Change Application (Minor Change) Town Planning Assessment

321 Priestdale Road, Rochedale

MEWING PLANNING CONSULTANTS

***Figure 3**: Tree retention plan*

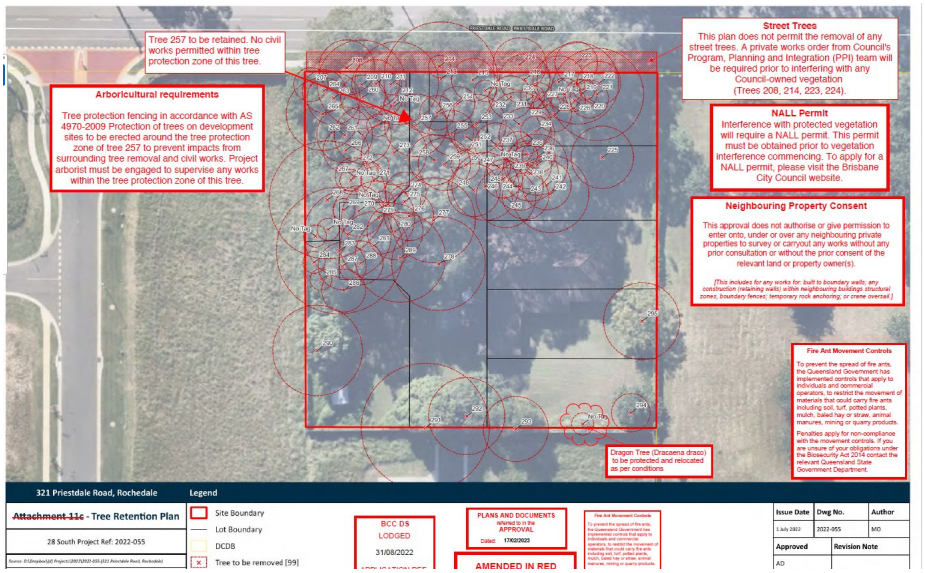
As part of the development approval Council amended the tree retention plan to require the retention of Tree 257 in the northwest portion of the site and within the road reserve. The amendment included the following note "Tree 257 to be retained. No civil works permitted within tree protection zone of this tree". **Figure 3** illustrates the amendment to the Tree Retention Plan.

To reflect the proposed change we request that council remove the approved mark up to the Tree Retention Plan as illustrated in the table below.

Table 3 – Changes to Conditions	
Condition	**Reason for Change**
10) Vegetation Management (Approved Plan) *Manage vegetation on the site in accordance with the approved Tree Retention Plan (received 31/08/2022 ~~and amended in red 06/12/2022).~~*	Condition 10 requires an administrative update to refer to a revised Tree Retention Plan.

***Figure 4**: Approved civil plan*

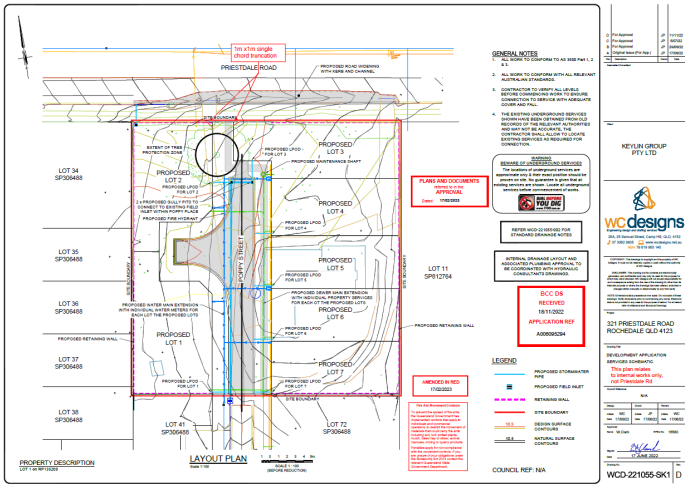
Notwithstanding the amendment to the Tree Retention Plan other approved plans showed civil works within the TPZ of Tree 257. Refer to **Figure 4**.

The requirement to retain Tree 257 presents a constraint to undertaking the civil works necessary to implement the approved subdivision. Civil Engineering 360 have cited the following engineer works as potentially impacting on the tree.

- Earthworks and levels – The footpath between the new road and Priestdale Road is identified within the TPZ. The existing levels within the TPZ would dictate the grades of the footpath. A compliant road verge would therefore not be achievable.
- Overland flowpath for stormwater – To try and retain the tree the intent was to grade the road to the north and back-grade the stormwater to connect to the development to the south. Civil Engineering 360 have reviewed the stormwater (piped system) and can get the major flows from the sag pits at the end of the road into the existing system to the south, however, in the event of a

blockage to these sag pits there is limited capacity to grade/shape an emergency overland flow path due to the TPZ of the tree.

The better engineering outcome is to grade the road to the south to the stormwater detention and treatment areas. The attached sketch plans prepared by Civil Engineering 360 show the extent of filling around Tree 257 to achieve compliant road verge and suitable overland flow paths, including emergency (blocked case) overland flow.

Having regard to the above, Civil360 Engineering concludes that the removal of Tree 257 will facilitate a superior engineering outcome, allowing the approved subdivision infrastructure to be delivered in accordance with the relevant engineering design requirements.
